**PUBLIC MEETING: JULY 11. 2019**

**GEORGE WASHINGTON  
MEMORIAL PARKWAY**

**TRAFFIC STUDY AND  
SAFETY ASSESSMENT**

PUBLIC INPUT

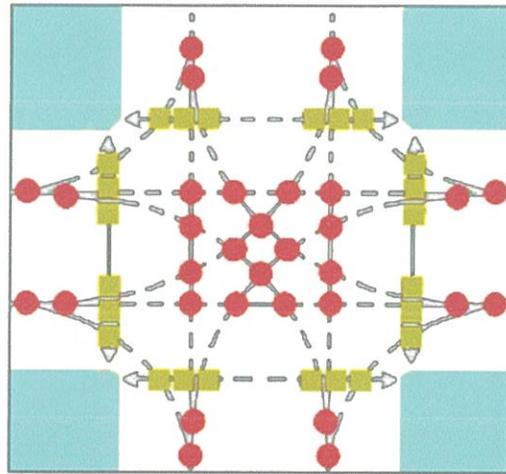
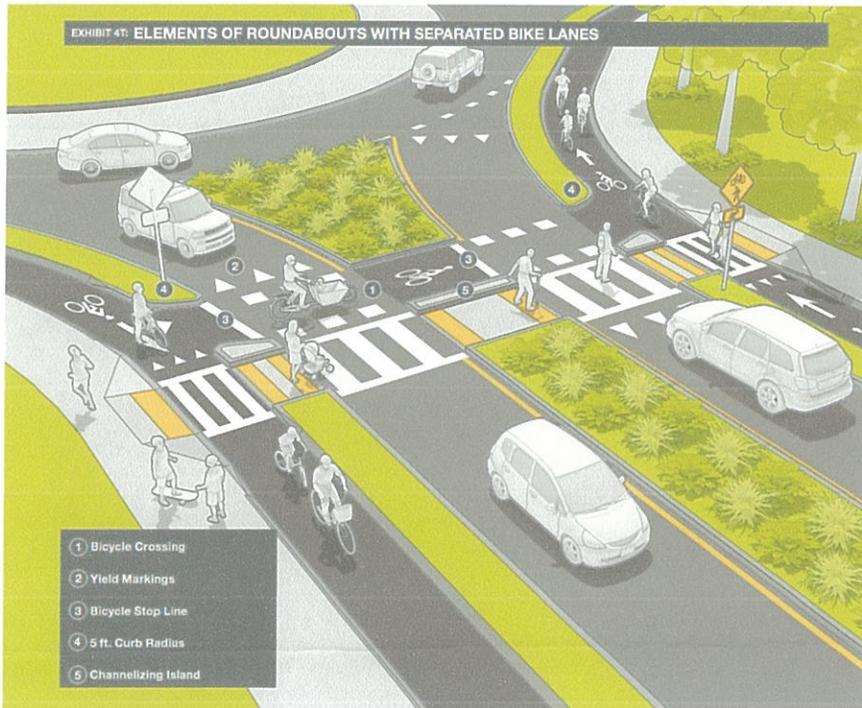
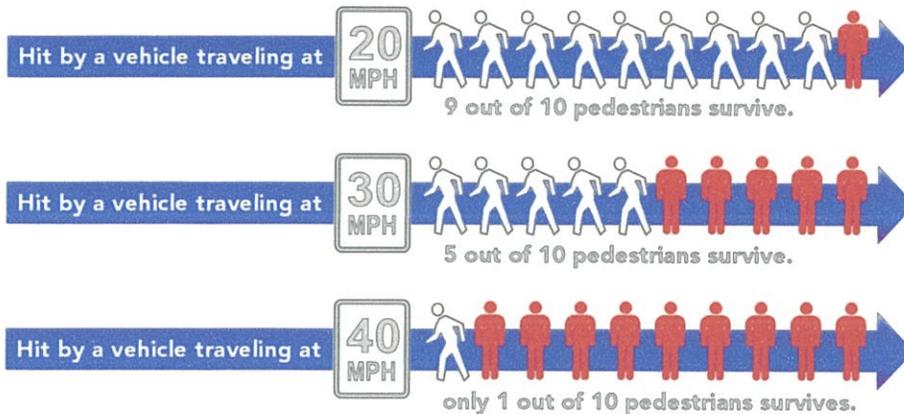
# Roundabout

● 8 Vehicle conflicts  
 ■ 8 Pedestrian conflicts

# Intersection

● 32 Vehicle conflicts  
 ■ 24 Pedestrian conflicts

Added graphic to highlight the vital importance of slowing traffic at conflict points:
